**Re: Rapiscan AIT System Radiation Survey Reporting**

<b>Rapiscan</b> systems	<b>Secure 1000 Radiation Emission Measurement</b>	FORM R-0646-1 (Single Pose)
----------------------------	---	--------------------------------

## R-0646-1 Addendum (Documentation Errors)

Product Name	Secure 1000SP (Single Pose)
Serial Number	S51006006
Radiation Emission Measurement	Radiation Survey Dated: 06/12/2010
RSO Initials	[REDACTED]

**2. Radiation Leakage Measurement: Survey Table. 2**

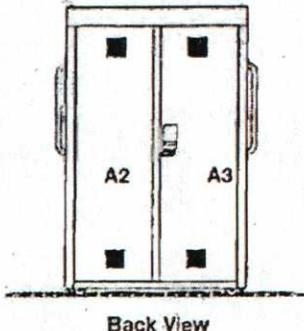
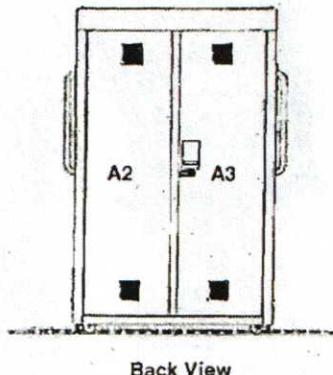
1. No value indicated for background radiation. Typical values range from 7uRem/hr to 13uRem/hr at sea level. Note: Absence of value has no adverse impact on calculations.
2. Technician indicated scan time as 7 seconds. Correct scan time is 3 seconds.
3. TABLE 1: Incorrect presentation of data in Column 3 for Measured Exposure. Indicated values are 45uR and 37uR. Corrected values are 4.5uR and 3.7uR. The values were corrected by technician when calculating Effective Dose.
4. TABLE 2: Incorrect presentation of data in Column 6 for Dose Equivalent. Indicated value is .18 uRem. The correct value should be 1.8 uRem.

The service technician should attend refresher training.

The corrected data indicates this system was operating within expected parameters. No re-survey is required for this system.
